Docket Item # 1
BAR CASE # 2010-0217

BAR Meeting
September 15, 2010

ISSUE: Alterations
APPLICANT: Soonja Purdy
LOCATION: 600 South Washington Street
ZONE: CL / Commercial

Figure 1. Plat showing location of propose units.

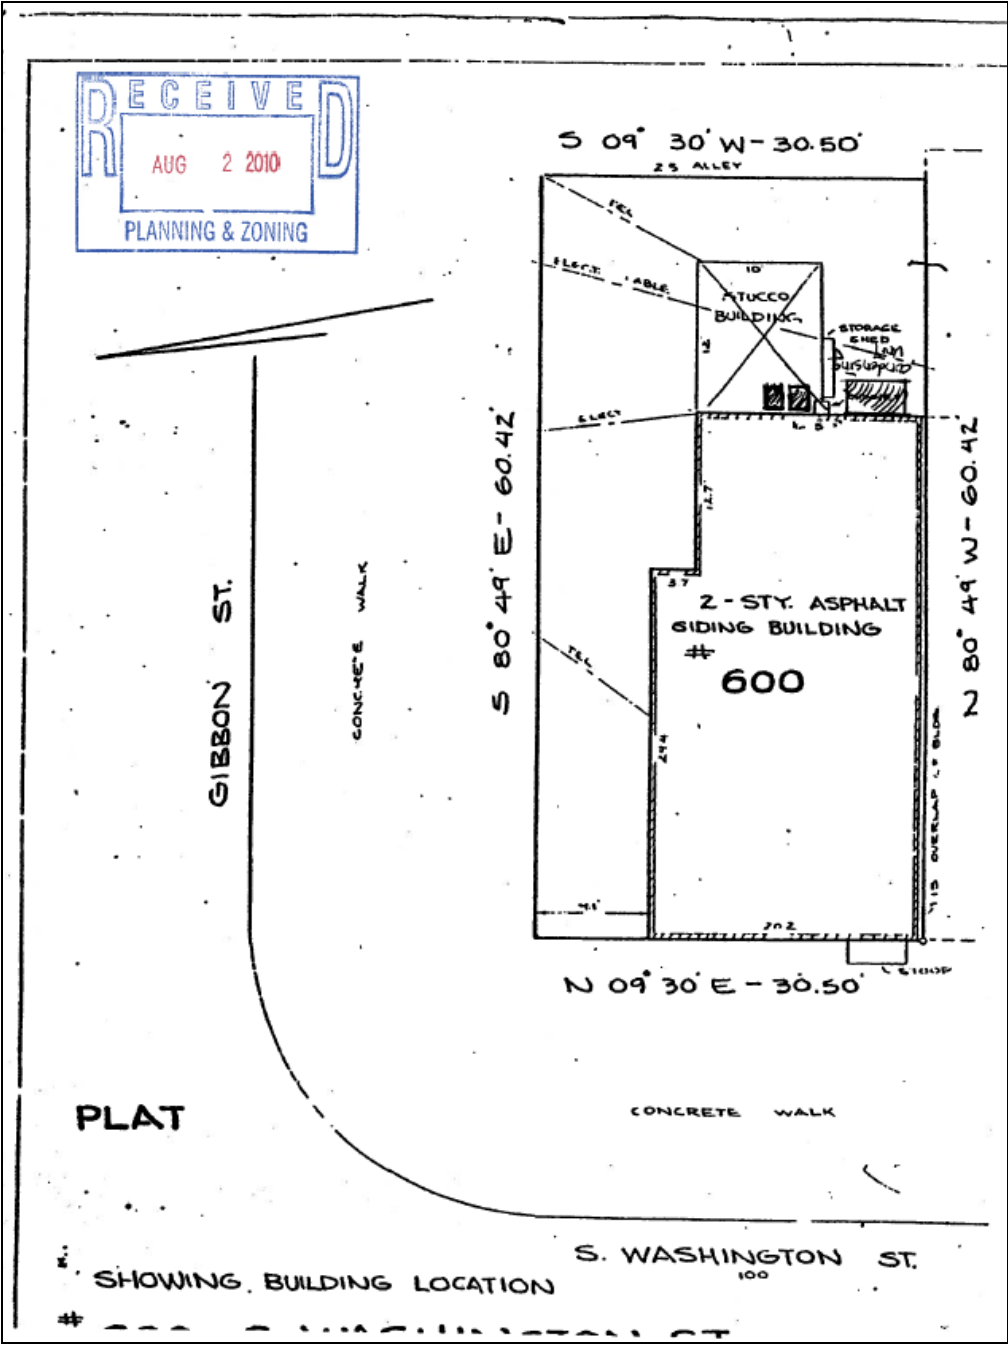
The proposed screening would be more appropriate if it screened the rear area with the concrete pad, garbage cans and the like. Staff recommends locating the fence in line with the rear ell and extending it to the rear property line. The applicant can fully enclose this rear portion if desired. As this application suggests that central AC has been installed, Staff recommends that the existing through-the-wall unit be removed and that the void be patched with siding to match the existing.

1. That the applicant work with Staff to determine an appropriate location for the rear fence to screen the HVAC, concrete pad and garbage area;
2. That the new fencing be painted or stained;
3. That the existing rail fence be removed; and
4. That the existing through-the-wall AC unit on the rear elevation be removed and the siding patched to match the existing.

Figure 3. Existing conditions at rear elevation.

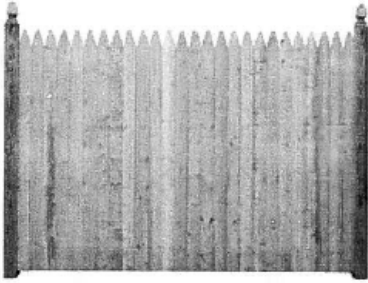
Staff notes that the existing painted rail fence is not historically appropriate and recommends that it be removed.
